CALIFORNIA COASTAL COMMISSION

STAFF REPORT: REGULAR CALENDAR

Application No.: 4-18-0206

Project Description: Repair, protect and reopen pier at Gaviota State Park through installation of 1700 tons of rock rip-rap, 90-ft. seaward extension, replacement of pilings as well as removal and replacement of timber decking and supports, and after-the-fact authorization for installation of upgraded boat hoist.

Hard Substrate

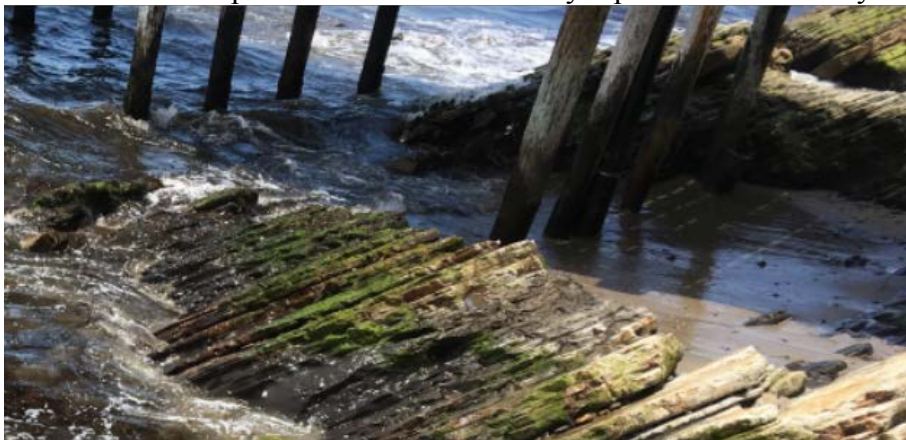
The proposed installation of a rock rip-rap revetment at the landward pier abutment would result in adverse impacts to hard substrate habitat and associated biota. Hard substrate is exposed rocky seafloor or intertidal area that provides habitat for a diverse group of plants and animals. Common epifaunal invertebrates occurring in the hard substrate areas vary based on depth, substrate relief height, and air, sun, and wave exposure. Along much of the California coast, there is a strong positive association between the types of communities and the depths and substrate types in which they occur. Hard substrates, including rocky bottoms, rock outcrops, tidepools, and rock crevices, provide habitat and shelter for numerous sessile organisms, fishes, and mobile invertebrates such as lobsters and crabs. In shallower waters and intertidal areas, many species of algae, surfgrass, anemones, starfish, and shellfish are present on hard substrates.

Hard substrate (especially high-relief substrate) and its associated biota are relatively rare in the Southern California Bight, and therefore any effect to them is potentially significant. Impacts to high-relief substrate in particular are significant because: (a) they support a diverse assemblage of epifaunal invertebrates; (b) they can attract fish as a nursery ground, food source, and as shelter; and (c) epibiota residing on rocky substrates are sensitive to mechanical disturbance and increased sediment loads.

Although portions of the hard substrate reef within the approximately 2,500 square foot area proposed to be covered by the rip-rap revetment near the base of the pier appear to provide less productive habitat due to shading from the pier and natural mechanical disturbance, scour and burial by sand and cobblestones, other portions of this natural reef have higher-relief and provide more stable habitat for a diverse range of marine species (as shown in the images on the following page and in [Exhibit 3](#)). Because of the layered configuration of the natural rock outcroppings that make up these higher-relief areas, they provide particularly high quality intertidal habitat with a high surface area and extensive systems of natural cracks and crevices used as refuge from predation and desiccation stress.

Condition 5 would prohibit installation of a rock revetment at the pier landing and require State Parks to submit revised project plans that do not include it.
